Access Compliance Report Public Rights-of-Way (Curb Ramps)

Main Street: **HAMER_DR** Cross Street: **CARTLEN_DR** Location: **NE**

ADA ID: **RPRK210917152521** Ramp Type: **Type 1 - Perpendicular Diagonal Initial Pass/Fail: Fail** Overall Compliance: **No** Severity Score: **2**

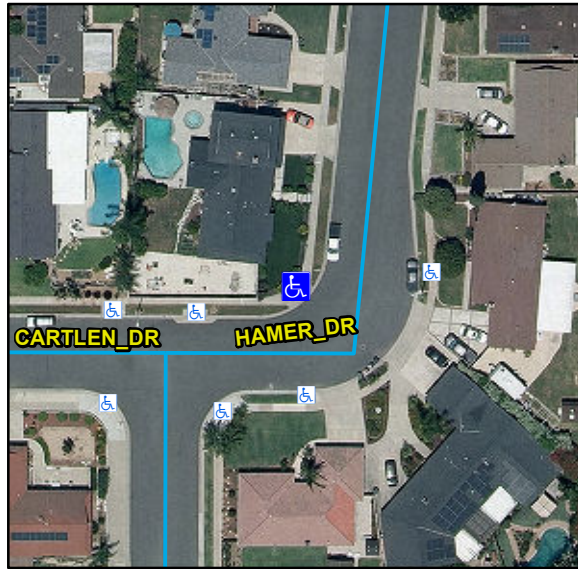
R304.2.2, R304.5.3, STD 1115

Compliance	Description	Data	Compliance	Description	Data
N/A	Ramp Length (in)	110	N/A	Flare Type LT	
Yes	Ramp Width (in)	48			N/A
Yes	Ramp Run Slope (%)	5.1	N/A	Flare Slope LT (%)	N/A
No	Ramp Cross Slope (%)	3.5	N/A	Flare Traversable LT	N/A
N/A	Landing Present	N/A	N/A	Flare Type RT	
N/A	Landing Length (in)	N/A			N/A
N/A	Landing Width (in)	N/A	N/A	Flare Slope RT (%)	N/A
N/A	Landing Run Slope (%)	N/A	N/A	Flare Traversable RT	N/A
N/A	Landing Cross Slope (%)	N/A	N/A	DWS Provided	N/A
N/A	Landing Movement Obstructed?	N/A	N/A	DWS Contrast	N/A
	Landing Movement Type	N/A	N/A	DWS Length (in)	N/A
N/A	Landing Shared	N/A	N/A	DWS Full Width	N/A
N/A	Clear Space	Yes	N/A	DWS Offset Left (in)	N/A
N/A	Clear Space To Crosswalk (in)	N/A	N/A	DWS Offset Right (in)	N/A
N/A	Marked Crosswalk 1	No	N/A	Marked Crosswalk 2	No
	Crossing 1 Direction	S		Crossing 2 Direction	E
	Marked Crosswalk 1 Width (in)	N/A		Marked Crosswalk 2 Width (in)	N/A

N/A	Ramp Inside Crosswalk 1	N/A	Yes	Ramp Inside Crosswalk 2	N/A
	Crossing 1 Slope (%)	7.4		Crossing 2 Slope (%)	8.4
	Crossing 1 Cross Slope (%)	5		Crossing 2 Cross Slope (%)	0.5
N/A	Gutter Ponding	N/A	No	Curb Slope	13.7
Yes	Gutter Lip Height (in)	0		Road Run Slope (%)	2.3
N/A	Gutter Run Slope (%)	N/A		Road Cross Slope (%)	8.3
N/A	Gutter Cross Slope (%)	N/A			
Yes	Overall Surface Condition: Acceptable		Yes	Perp Joint Present	Yes
	Cross Gutter Present?	No		Spandrel Present?	No
	Replace Cross Gutter?	N/A		Replace Spandrel?	N/A

Remove & Replace Curb Ramp With Two New Directional Ramps or Equivalent.
